4FRI Rim Country Project

Final Environmental Impact Statement

Volume 3

Figure E-2. 4FRI adaptive management process

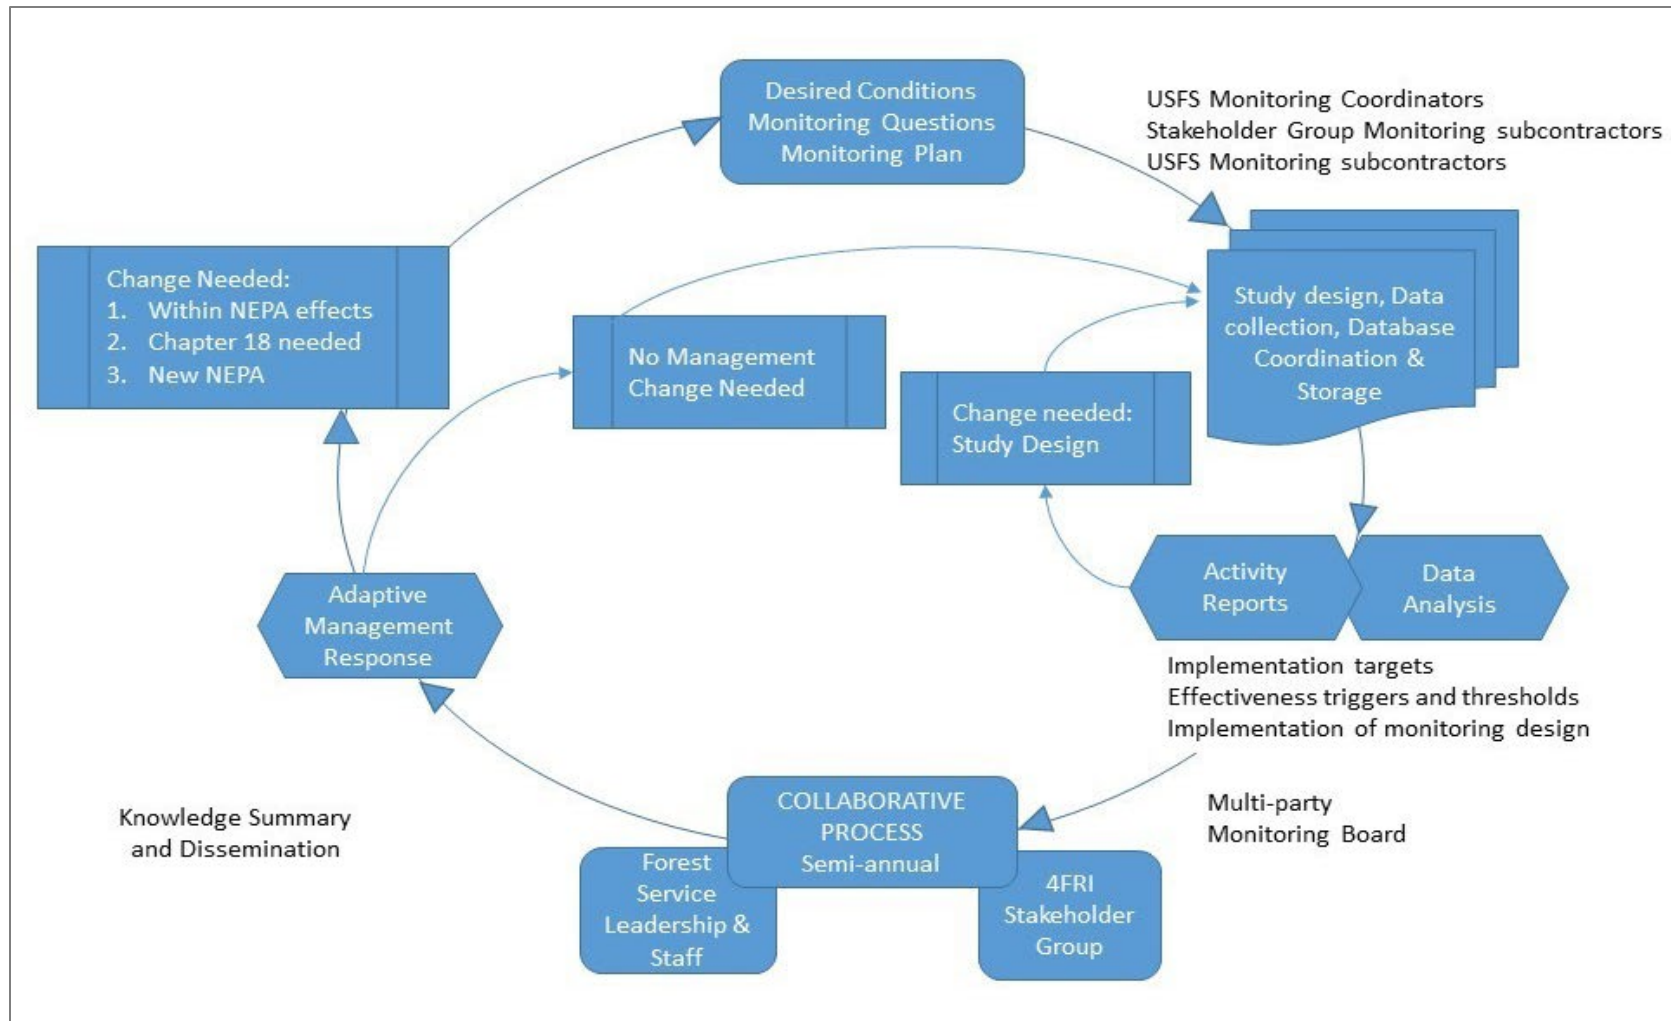
3. *CONCERN #8: Additional detail is needed on the adaptive management process. RECOMMENDATION #8: ECO recommends that the Monitoring Plan (RC DEIS Appendix E) more clearly articulate specific steps in the monitoring and adaptive management process (as illustrated in Figure 100) and indicate that decisions will be made in collaboration with ECO and MPMB. 39.52*

8. *The SHG recommends that the Monitoring Plan (RC DEIS Appendix E) more clearly articulate specific steps in the monitoring and adaptive management process (as illustrated in Figure 100) and indicate that decisions will be made in collaboration with the SHG and MPMB. 32.41*

The Forest Service and 4FRI Multi-Party Monitoring Board have updated figure 100 and the narrative in the adaptive management process section of the Rim Country monitoring and adaptive management plan (appendix E) to clarify them both. The role of the 4FRI Multi-Party Monitoring Board and 4FRI Stakeholder Group, of which the Eastern Arizona Counties are a member, in the adaptive management process is explained in the adaptive management process section of the plan. The process by which adaptive management recommendations would be made to the 4FRI Stakeholder Group, and subsequently to the Forest Service, are laid out in the charter, which is available from the 4FRI Stakeholder Group.
